Kaplan Blade To Gate Parallelogram Spiral

Figure 9 Parallelogram spiral motion of Kaplan blades with GDACS 3-D cam plotted over McNary WithScreens 3-D cam profile surface.

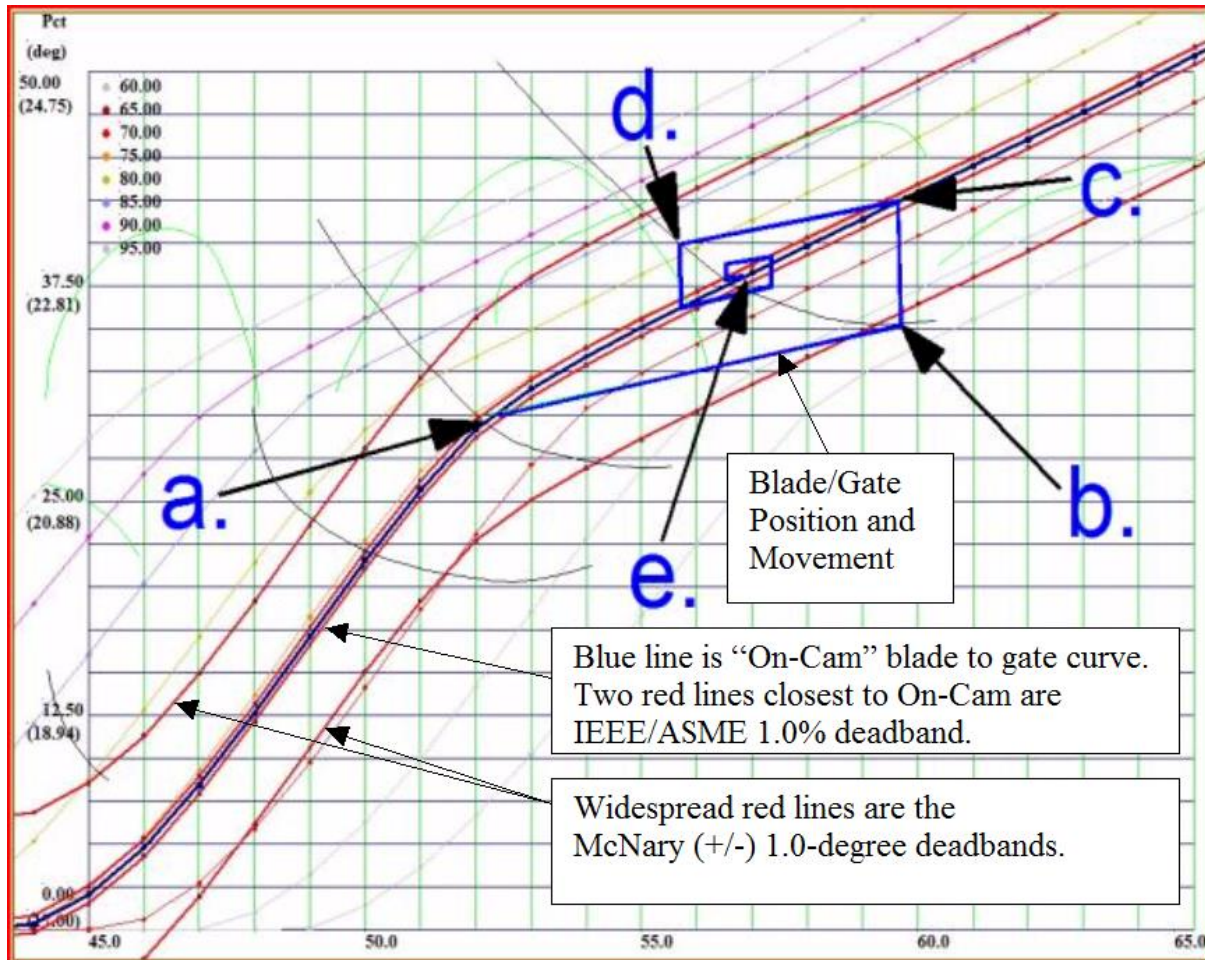
Dan's explanation of the GDACS 3-D cam behavior went like this (ref fig 9, below):

When a large upward SetPoint change is made in power,

Starting at (a.) on fig 9, the governor's speed motor is activated to raise the SetPoint by the GDACS control system,

Gates open rapidly to get the power output up to the new SetPoint level at the constant power curve at (b), with the desired target operating point at (e) on the on-cam line.

Power output is sensed by the GDACS control system, which continues opening the gates until the generation SetPoint demand is satisfied at (b).

During this first move, the blade to gate motion tracked the linear taper of the mechanical 2-D cam on the gate restoring shaft of the governor, tracing the line from (a) to (b) instead of tracking the “on-cam line” from (a) to (e) like a proper governor and 3-D cam should.

Due to the 35-second deadtime in the blade control system, the stepper motor does not move during the motion from (a) to (b), so the blades move only along the linear taper of the metal 2-D cam that is mounted on the gate restoring shaft. This causes the gates to open farther than they would have had the blade controller been robust and accurate, and the blade angle been able to track the on-cam curve from (a) to (e).

The blade controller wakes-up 35 seconds later, takes note of the change in gate position and then computes the new Ideal Blade angle, and then moves the stepping motor to complete the blade motion to the new Ideal Blade position for the existing gate at 75 ft head at (c) as dictated by the 3-D cam algorithm and the cam-data surface lookup table.

When the blades move up to this new, steeper position, power output of the unit increases significantly, exceeding the deadband set for the power level controller in the GDACS, so the closed loop on power in the GDACS pulls the gates back to get power back to the SetPoint at the constant power curve that extends from (b) to (d), and beyond.

After another deadtime of the GDACS load feedback, the speed motor is moved again to decrease power back down to the load SetPoint at (d). Again, the blades do not move in unison with the gates to track the “on cam line” from (c) to (e) because of the 35-second deadtime, so the blade to gates motion tracks the linear taper of the metal cam from (c) to (d) on the way down.

This motion continues until the blades are within the 1.0-degree blade deadband programmed into the Panel Mate touch screen control panel, then the blade controller stops making corrections to blade angle.

The cause of this “rectangular spiral,” (or to better characterize the impact this misalignment would have on flow turbulence & shear forces in the water and on any fish passing through the turbine during this sequence, we could call it a “*rectangular death spiral*”) is the bad dynamic behavior of the USACE designed blade actuator in the GDACS 3-D cam. To mask this problem, the control system was desensitized by adding a 1.0-degree deadband that prohibits blade motion if the blades are within 1.0-degree of the Ideal Blade position. This results in a permanent and continuous 6.5% blade position error away from the Ideal Blade position. (ASME/IEEE standard is 0.5%) There is also an associated deadband and deadtime on power level in the GDACS control system. These deadbands and deadtimes are a very crude method of desensitizing the turbine control systems so the machines’ unwanted motions don’t wear out the trunion bearings due to the inherent instabilities that the USACE HDC GDACS 3-D cams introduced.

The 1.0-degree deadband programmed into the GDACS 3-D cam, when evaluated per the ASME PTC-29 deadband measurement technique which *sums the residual error on both sides of the optimum cam line*, becomes a 12.9% deadband. When this is added to the anticipated 2.0% deadband from mechanical hysteresis of the blade positioning system of these 50+ year-old machines; *the deadband is about 15%*.

IEEE Std-125 quantifies an acceptable deadband at 1.0%, a standard that all other hydroturbine 3-D cam and blade control equipment suppliers meet or exceed. This is not a mandate, however, just a guideline indicating what is reasonable and customary throughout the industry for contracting agents (such as USACE's Contracting Office in Portland) to use in specifying hydroturbine control system equipment in the acquisition documents. It is incumbent upon the Contracting Officers to mandate that the equipment be in compliance with the industry-accepted nominal standards.
